THE CORPORATION OF THE CITY OF COURTENAY

Permit No. 3090-20-2304/DVP00046

DEVELOPMENT VARIANCE PERMIT

Riparian Areas Protection Regulation: Assessment Report

Section 3. Site Plan

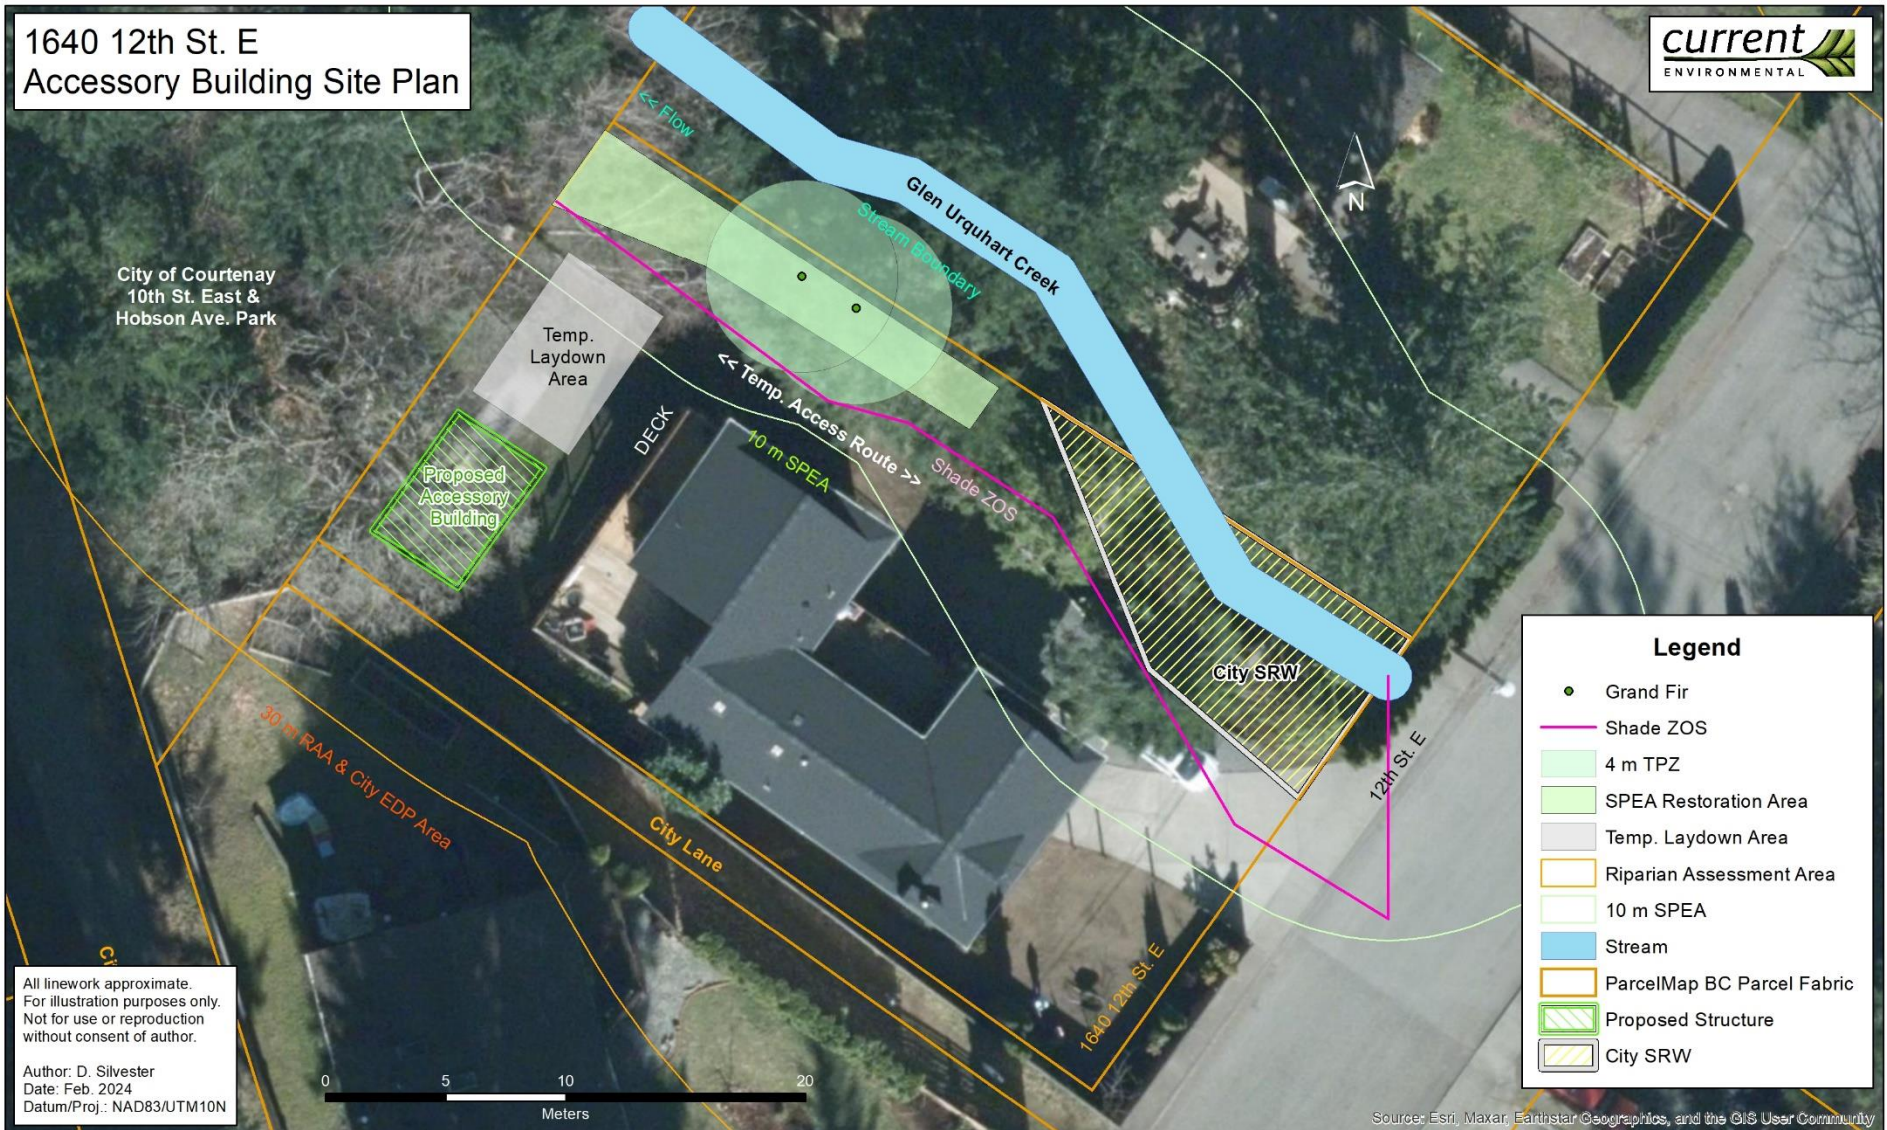
The deck is unpermitted and needs to be included in an updated 8267 report to ensure all works (proposed and currently built) are legalized. If the aerial photos used in the RAPR report is not georeferenced, remove it from the site plan as it shows the deck partially within the SPEA. Should any portion of the deck be within the SPEA, it will require removal.

1. No removal of natural vegetation will be required as the width of the machinery required for construction can traverse around the existing residence without vegetation removal (Section 3 – Site Plan).
2. Access routes, storage areas, and critical root zones are shown in the updated Section 3 – Site Plan.
3. Horizontal and vertical protection for root zones is detailed in Section 1.4. Protection of Trees.
4. Specific tree protection measures and root protection radiuses are shown in Section 3 – Site Plan.
5. Post-development reporting will include photos documenting measures in place. The owner must contact the QEP a minimum of 7 days prior to commencing construction for a site visit to confirm the measures have been installed effectively.
6. Restoration and enhancement measures are included in this section below.

Figure 2. BCLS Site Survey showing deck location on the east side of the residence measured at 10.7 m from the stream boundary of Glen Urquhart Creek.

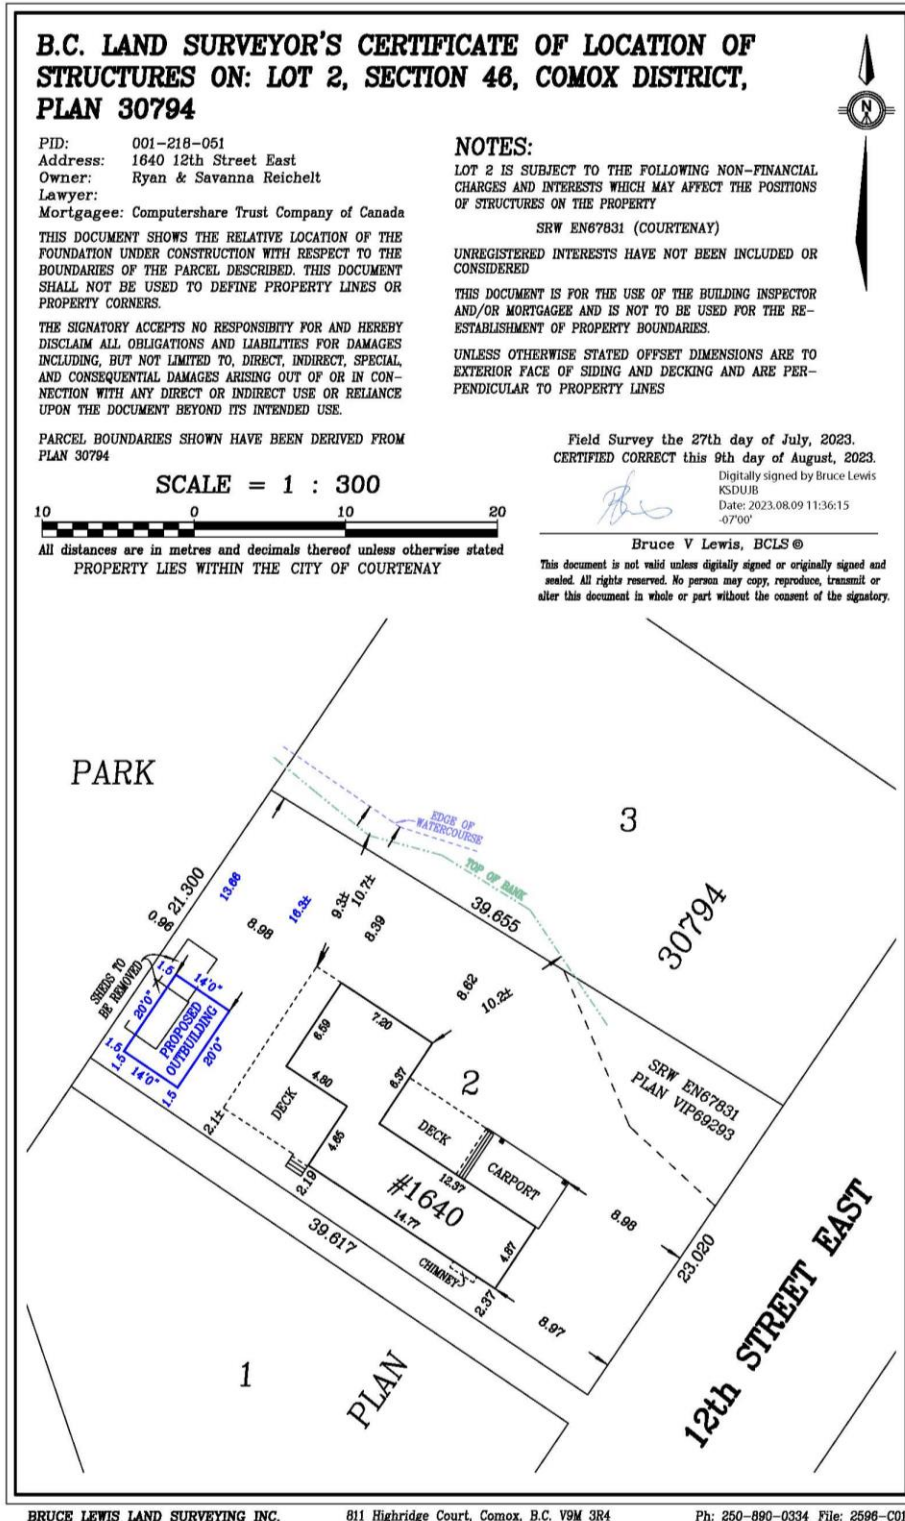
Per RAPR methods, please ensure the SPEA is measured horizontally from the *Stream Boundary*.

Please confirm the “water’s edge” or as depicted on the plan below “edge of watercourse” in relation to your determined Stream Boundary (attached).

I have spoken with the applicant, Ryan Reichelt in reference to the site survey that was recently shared with me showing the deck in question being 10.7 m from the water's edge -according to the BCLS. This is outside the 10 m SPEA and calls into question the invalidation of the RAPR report on the basis that past work (pre-dating the RAPR report submission) may not have occurred within the SPEA -but, yes, within the RAA and City DP.

In response to RARNS review comments (email thread in Appendix) this update provides additional context on a historical, unpermitted deck addition to the existing residence that occurred within the Riparian Assessment Area prior to the QEP site investigation that formed the basis of this assessment. In the interim, a site survey by a BCLS was obtained that provided an accurate fix on the stream boundary as well as showing the distance between the nearest stream boundary point and the deck addition (Figure 2). This survey was succeeded by an additional site visit by the primary QEP from Current Environmental Ltd. to ground truth the BCLS' measurements. It was determined using a measuring tape of the horizontal distance between the nearest point of the deck to the stream boundary that the deck was constructed at 10.5 m (within a reasonable margin of error from the BCLS 10.7 m measurement) and confirmed that the deck is located outside the 10 m SPEA of the creek (Photo 6). As a result of the construction being within the RAA and the City's Development Permit Area, but outside the SPEA, the proponent will require a permit from the City to legitimize the deck construction but it is not considered a contravention of the RAPR and will not require remedial actions. The remaining, original conclusions of this report remain relevant and do not require further amendment.

I went out to site this morning and measured the edge of deck at 10.5 m from the nearest point on the left bank stream boundary of the creek (photo attached), outside the 10 m SPEA. Will the previously approved RAPR assessment still be considered invalid, and will the province require any additional reporting on the matter?
